babcock & wilcox nuclear operations group

Subject: Reply to Request for Additional Information (TAC L33356)

B&W Response to NRC Request for Additional Information

**Organization Charts Showing B&W
Existing Structure and Post-Spin Structure**

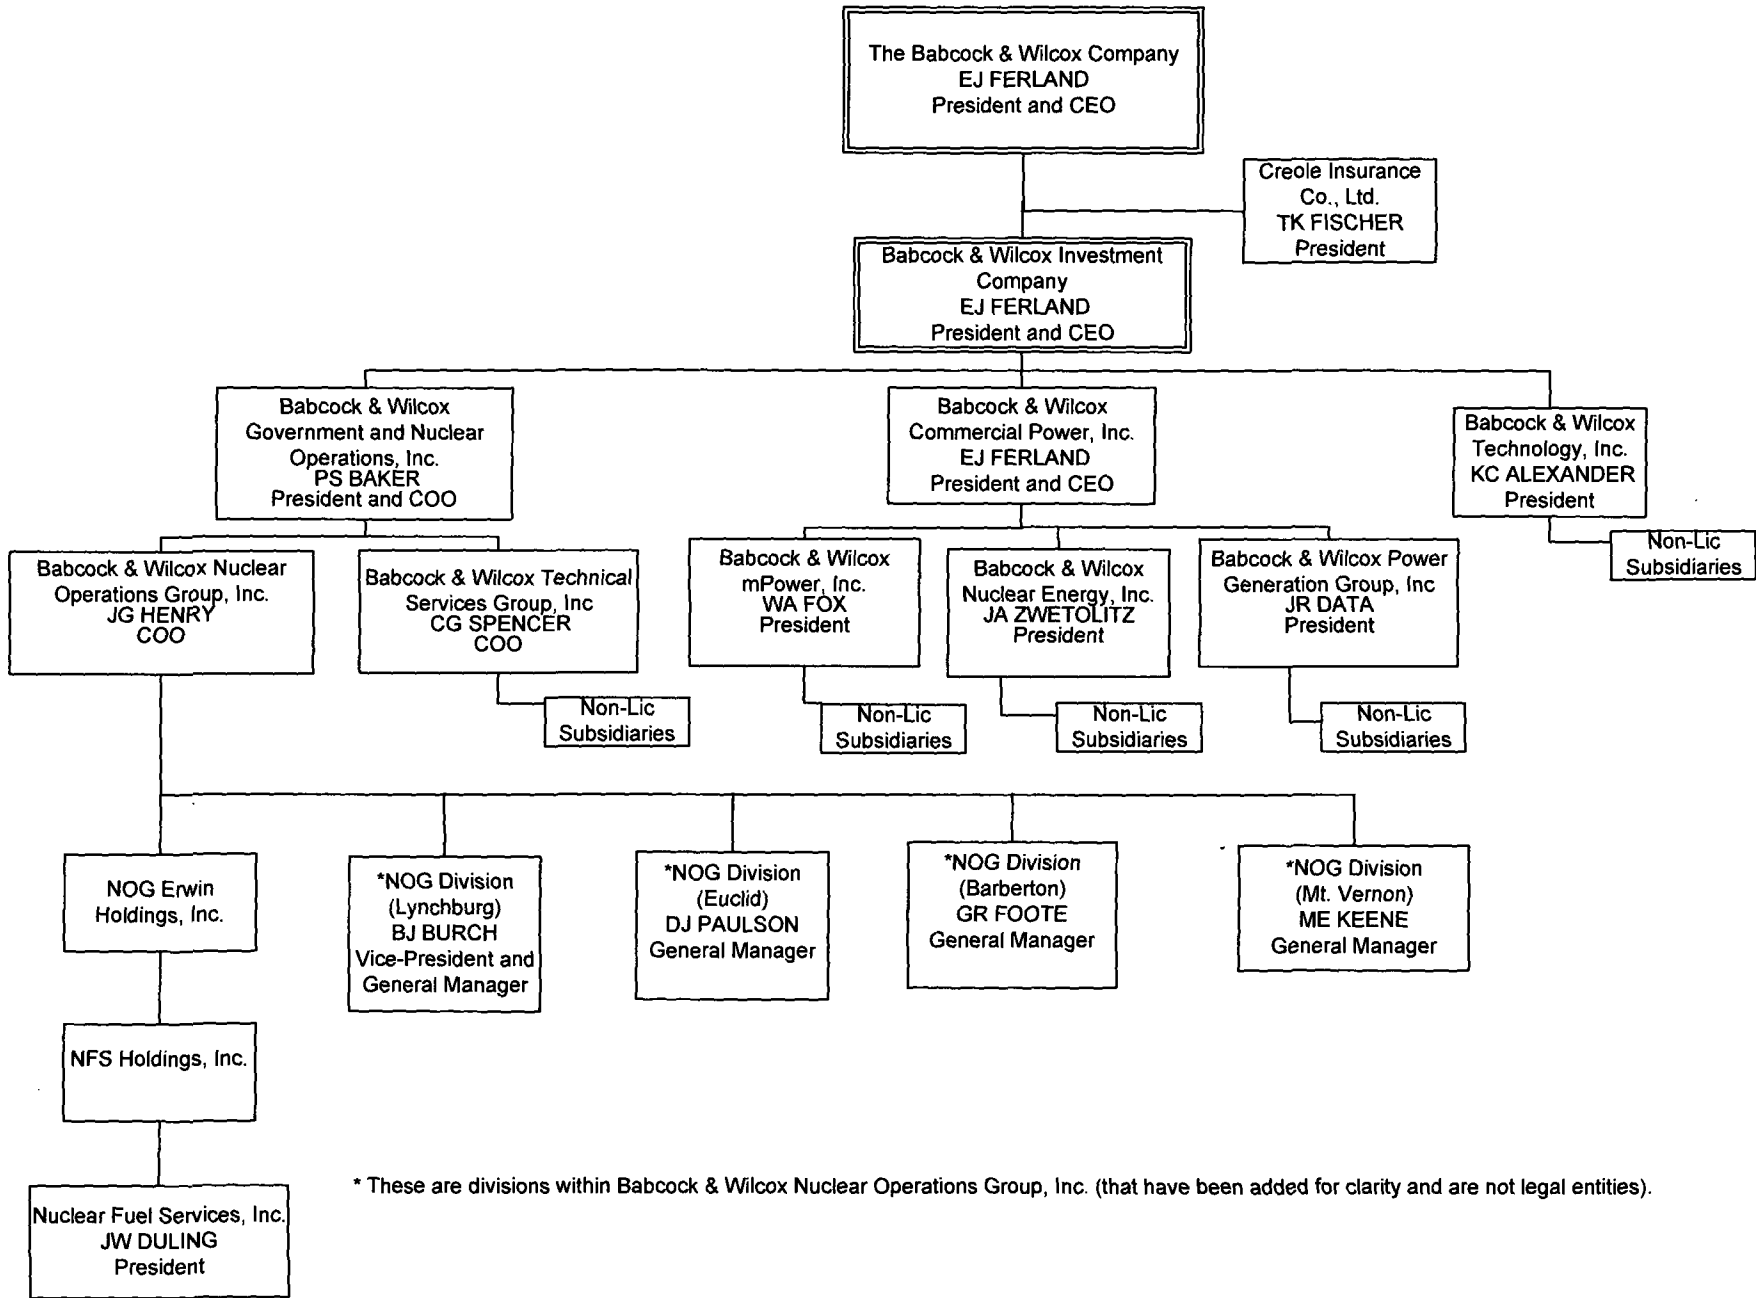
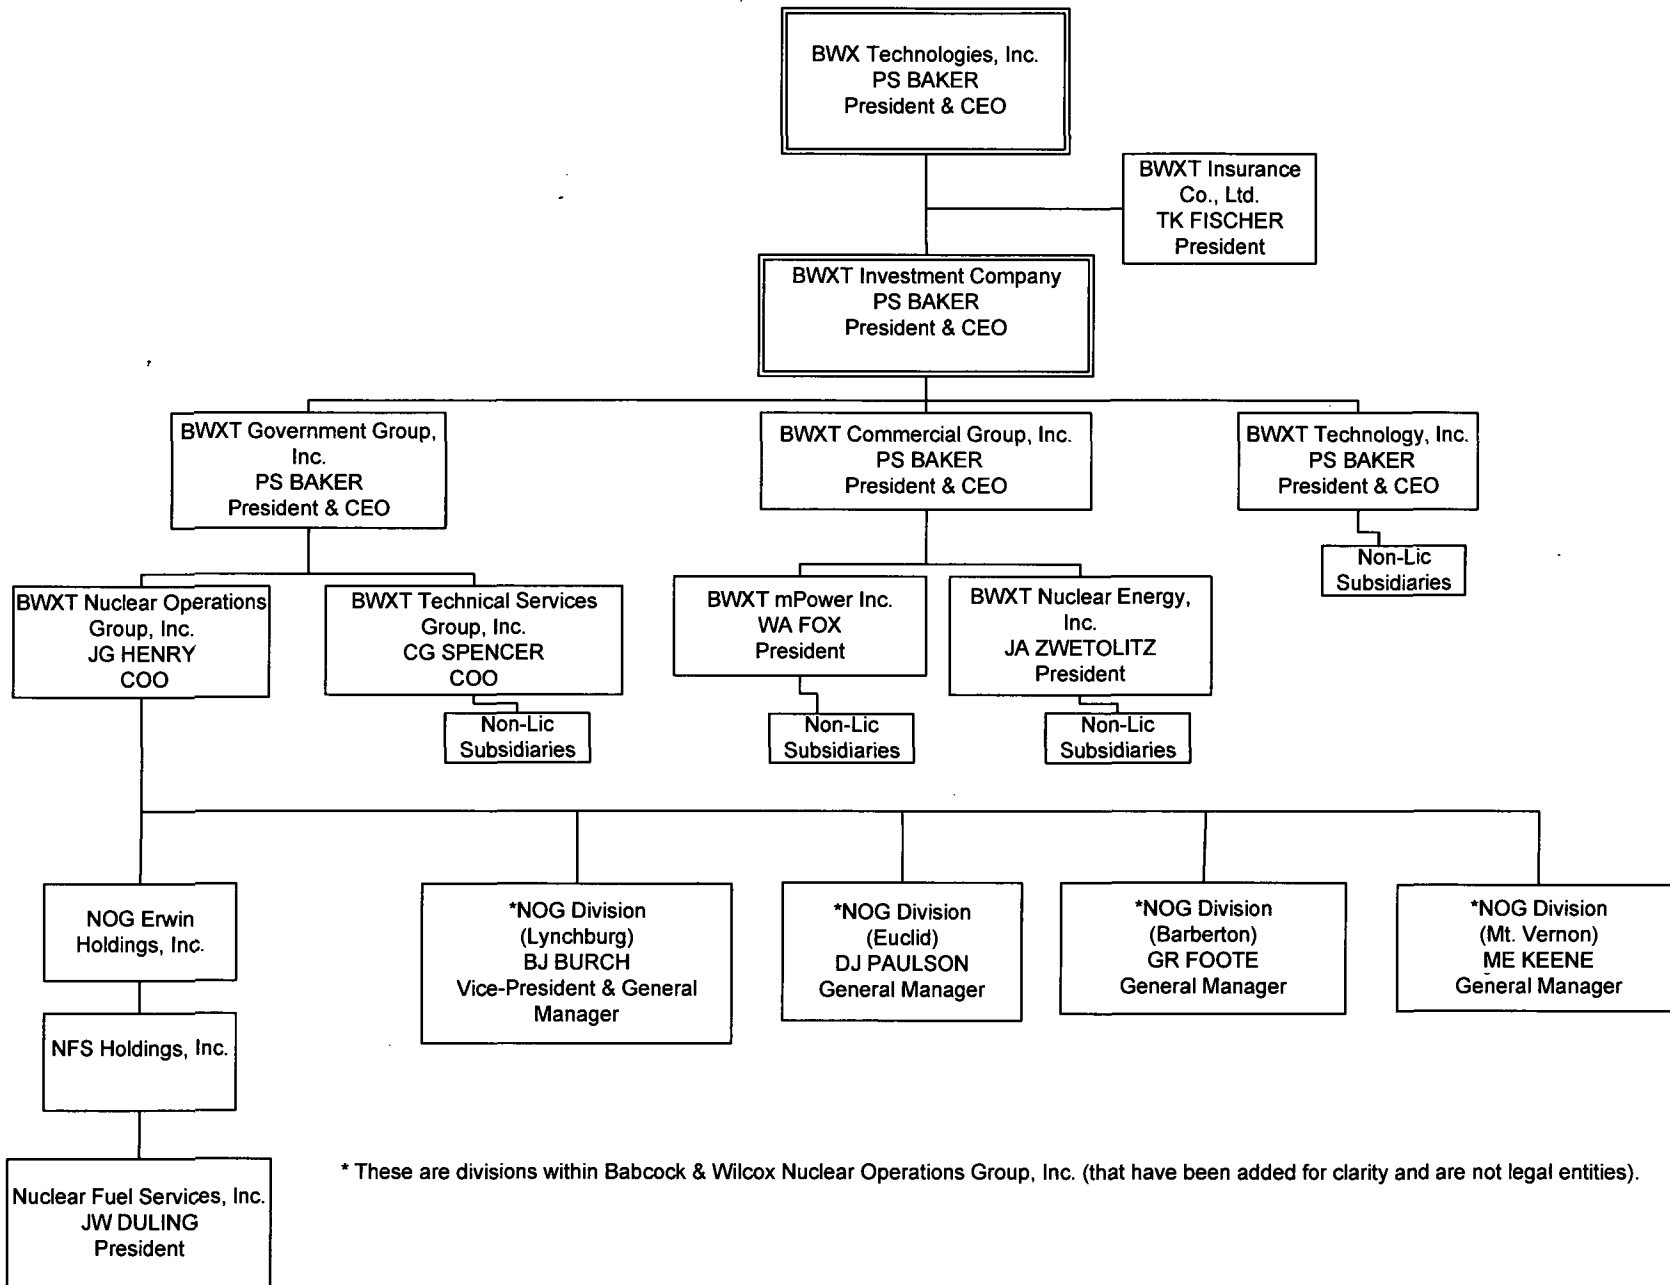
Item 1: Please provide Org charts (position and name, if available) for the companies in the BWXT chain, both before and after the spin-off.

In addition, during the December 15 telephone call, questions were asked as to whether Mr. Sandy Baker will hold all of the various executive positions identified in the organization charts, or whether his name was a placeholder in some instances. Mr. Baker's name is not a placeholder, and B&W fully anticipates that he will hold all of the executive positions listed in the organization charts.

On December 12, 2014, B&W provided to the NRC the requested organization charts. On December 15, 2014, B&W's representative, Mr. Charles England, followed up by phone with Mr. Merritt Baker, to clarify what additional information was needed.

In response to that conversation, B&W is hereby submitting pre and post spin-off organization charts (Enclosure 2) showing the relevant insurance subsidiaries, and providing the name of the President of both the existing insurance subsidiary and the post-spin insurance subsidiary that will be owned by BWX Technologies, Inc. following the spin-off. In both cases, that individual is Mr. Timothy K. Fischer.
